PROJECT: First Financial Bank
Fourth Floor Finish Out

PROJECT NUMBER: 13.011

ADDENDUM

Number: FOUR

NEW CEILING ON THIRD FLOOR
 SCALE: 1/8"=1'-0"

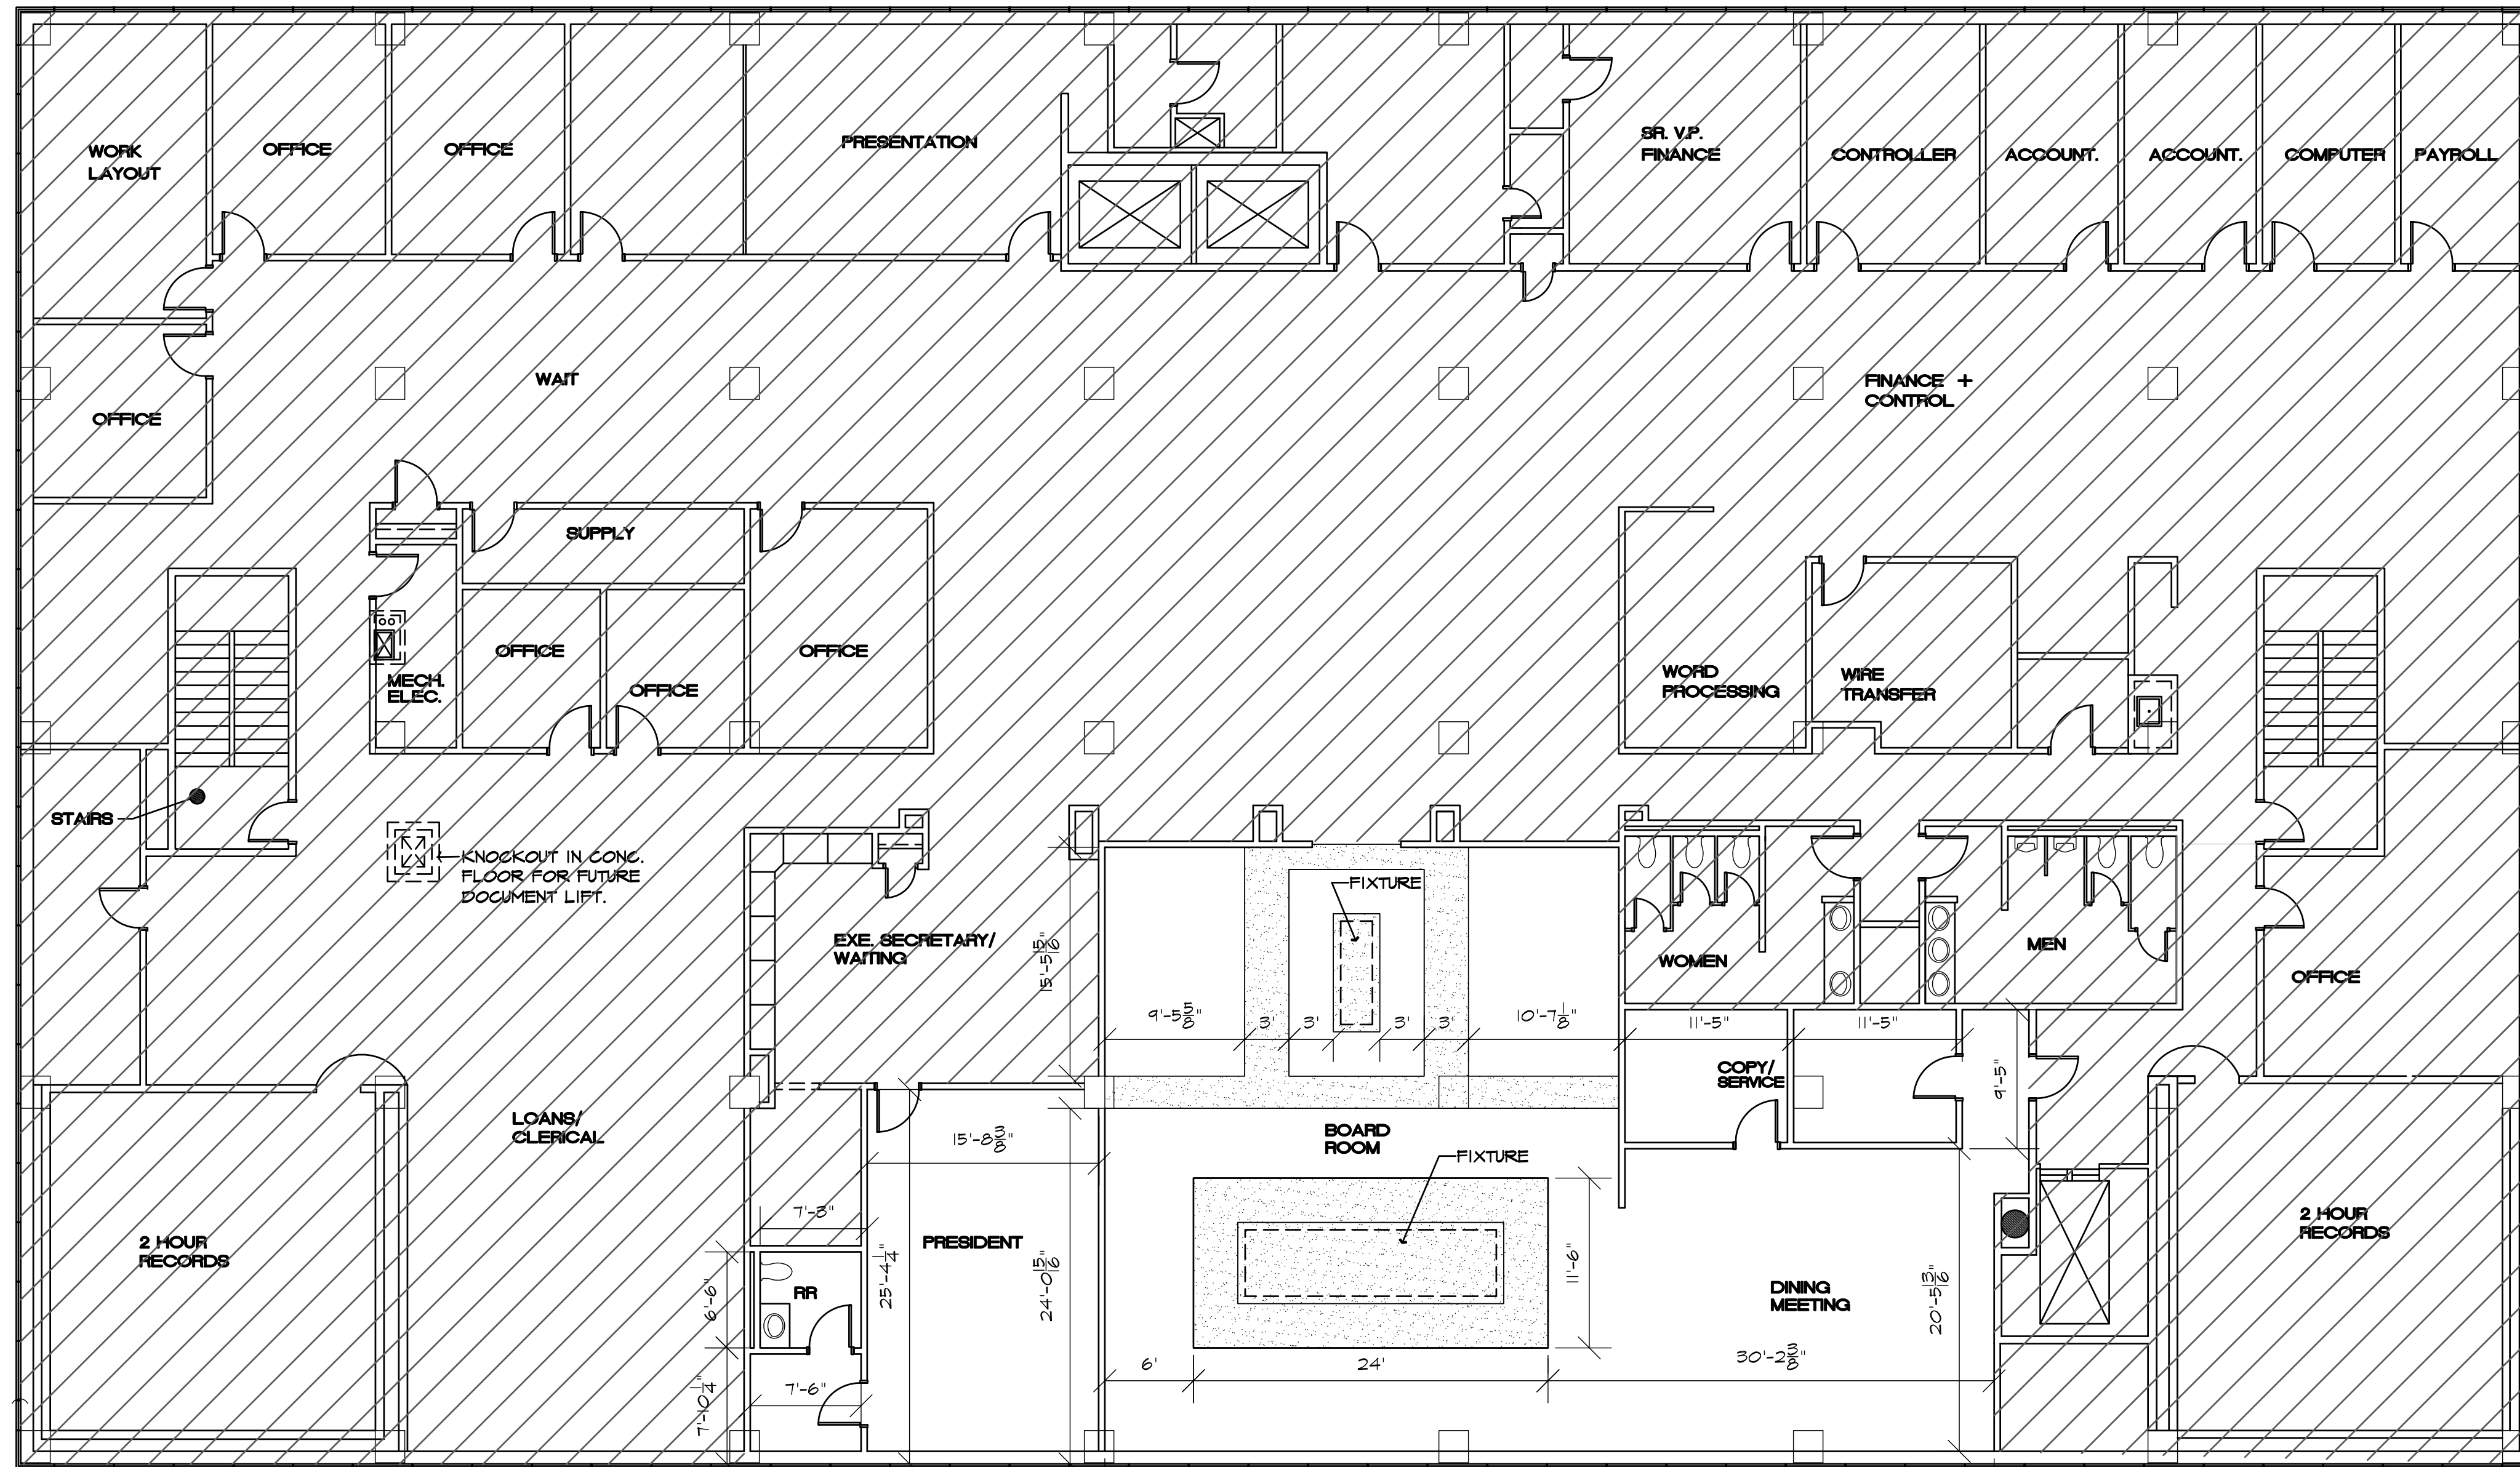
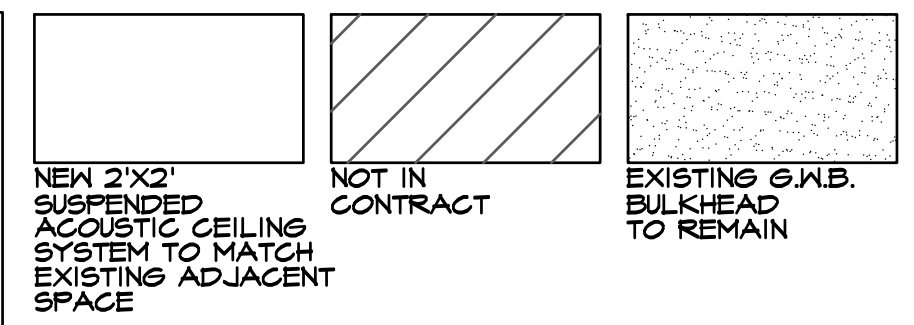
- 3.01 SD06: Addition to scope of work- Third floor ceiling
- 3.04 SD09: Addition to scope of work- Bulkhead in Conference Rooms
(SD07 & SD08 will be sent out with a separate Addendum)

REMOVE EXISTING CONCEALED SPLINE CEILING TILES IN AREA TO RECEIVE NEW 2X2 CEILING COMPLETE TO ACCOMMODATE ANY MECHANICAL, ELECTRICAL, IT, VOICE COMMUNICATION, AND/OR PLUMBING WORK ON THE FOURTH FLOOR.

REPLACE WITH NEW 2'X2' SUSPENDED ACOUSTIC CEILING SYSTEM TO MATCH EXISTING ADJACENT SPACE. FIELD VERIFY FOR EXACT MATCH AND SUBMIT TO ARCHITECT.

CEILING HEIGHT TO REMAIN AS CLOSE TO THE EXISTING AS POSSIBLE.

ALL CEILING MOUNTED ITEMS TO REMAIN IN CURRENT LOCATIONS.

1 **BULKHEAD ADDITION**
 SD09 SCALE: 1/8"=1'-0"

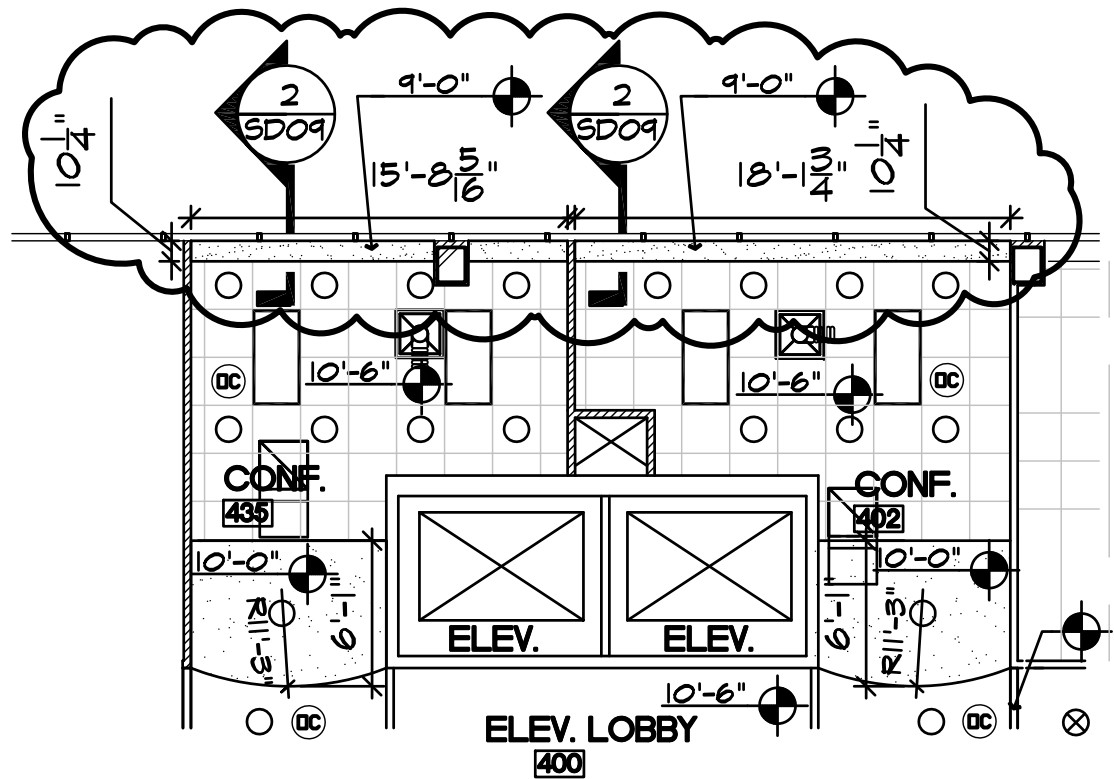
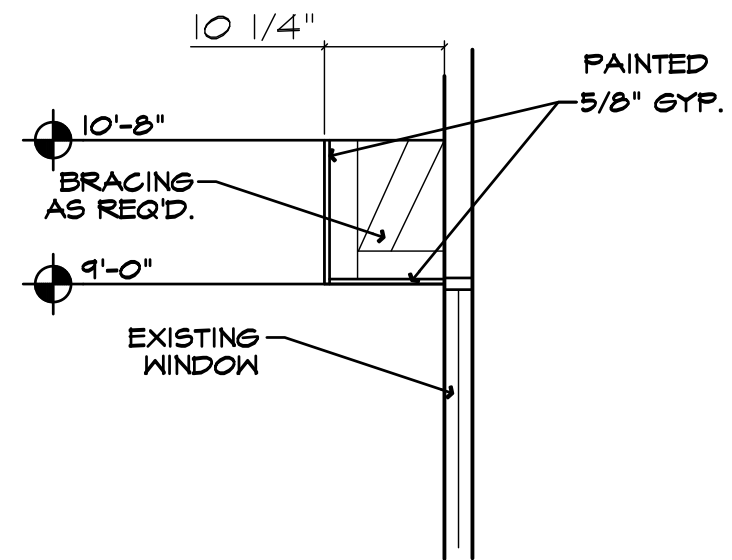
Ceiling heights to remain as originally planned. Extend ceiling grid to window frame which is at 9'-0".

Use detail on SD09 for Conference Rooms only.
